# Power Steering Light Illuminated for 20 Seconds After Vehicle Start

YEAR(S)	MODEL(S)	ADDITIONAL INFORMATION
2015 - 2016	Camry

Some 2015 – 2016 model year Camry vehicles produced at the SIA plant may exhibit an illuminated power steering light that stays on for 15 – 20 seconds before turning off after the engine starts. Follow the Repair Procedure in this bulletin to address this condition.

Figure 13.

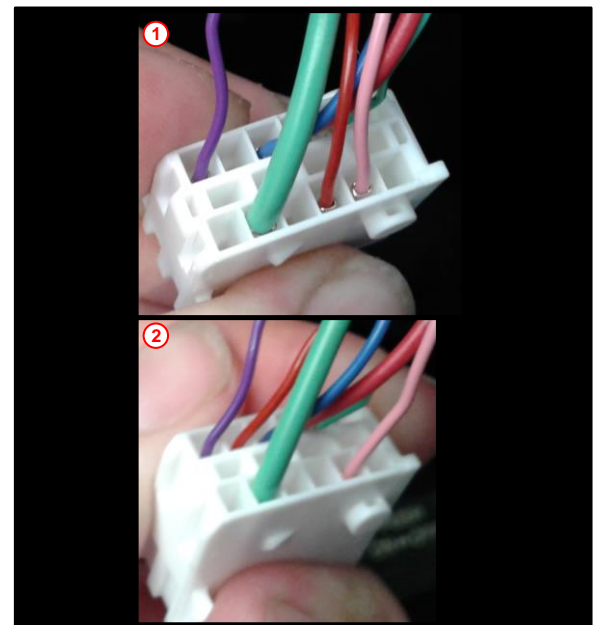
- Remove the red wire from Pin location 4 and place it into the empty cavity of Pin 14.

- The red wire MUST be placed next to the violet wire in pin 13 (see Figure 13).
- Use the SST to remove the PIN.  
Refer to the video link below for PIN removal instructions:

Figure 15.

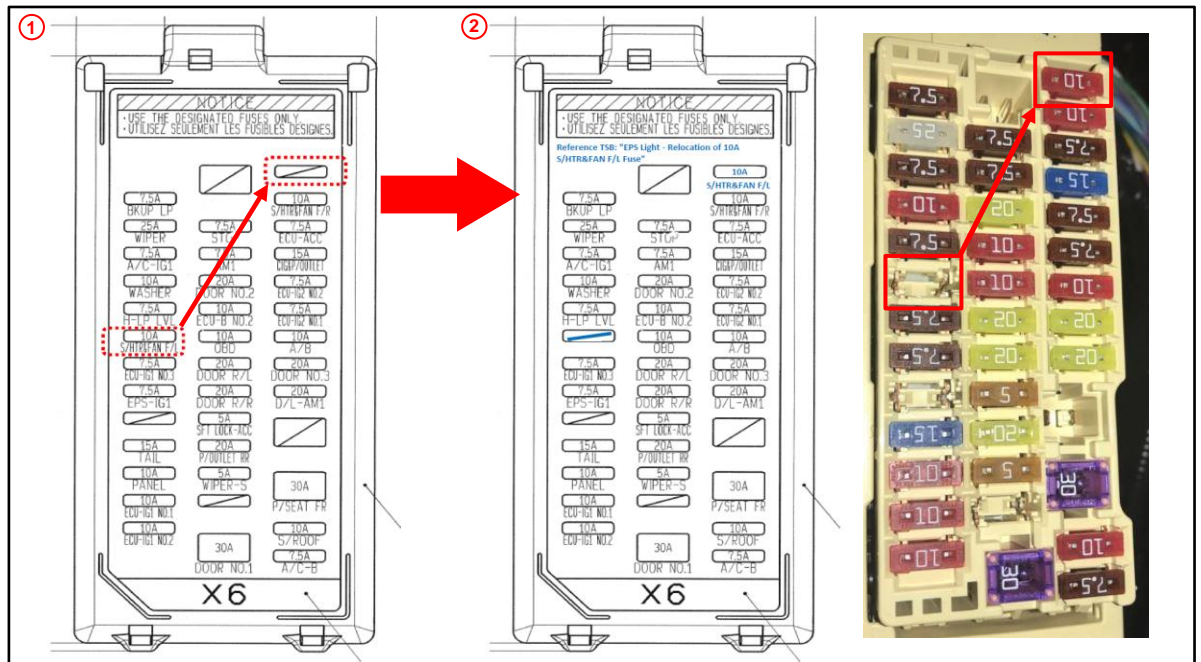
11. Replace the fuse location.
  - A. Remove the original fuse cover assembly as shown and discard.

- B. Remove the 10A fuse, "S/HTR&FAN F/L" from the current location and move it to the NEW location as shown.

12. Install the NEW fuse cover assembly.
13. Reassemble the connector and connect the No.1 floor wire connector.
14. Install the lower No.1 instrument panel finish panel assembly.
